**Summary Review of Issues Raised in Bishopdown Estate Report**

# Bishopdown Residents Association

## Survey of Bishopdown Estate – 2019

42

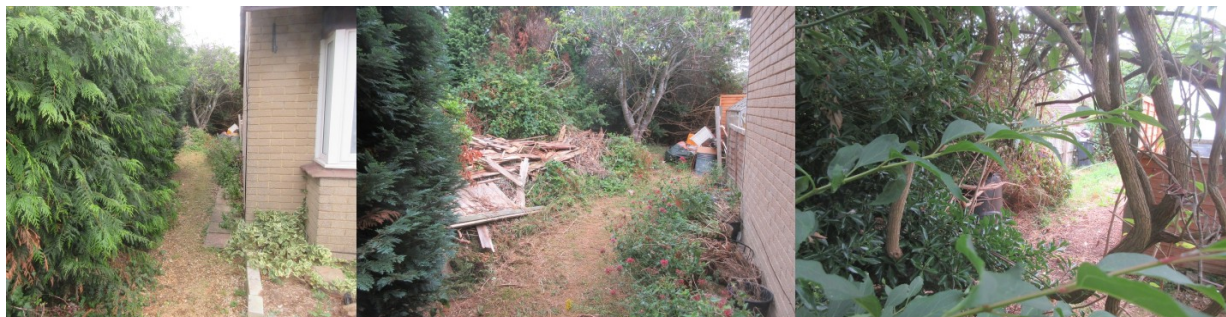
Footway in Hallum Close leading to Fison Walk. Many of the residents of Fison Walk are elderly and less-abled, several appear to use wheelchairs. This drop-kerb and footway are alike in poor condition, and are representative of general conditions.

It leads initially to this corner of land at the lower end of Fison Walk. This was a planning anomaly and has just been left blank and untended, it is not overlooked by the front of any property and often becomes a dumping ground.
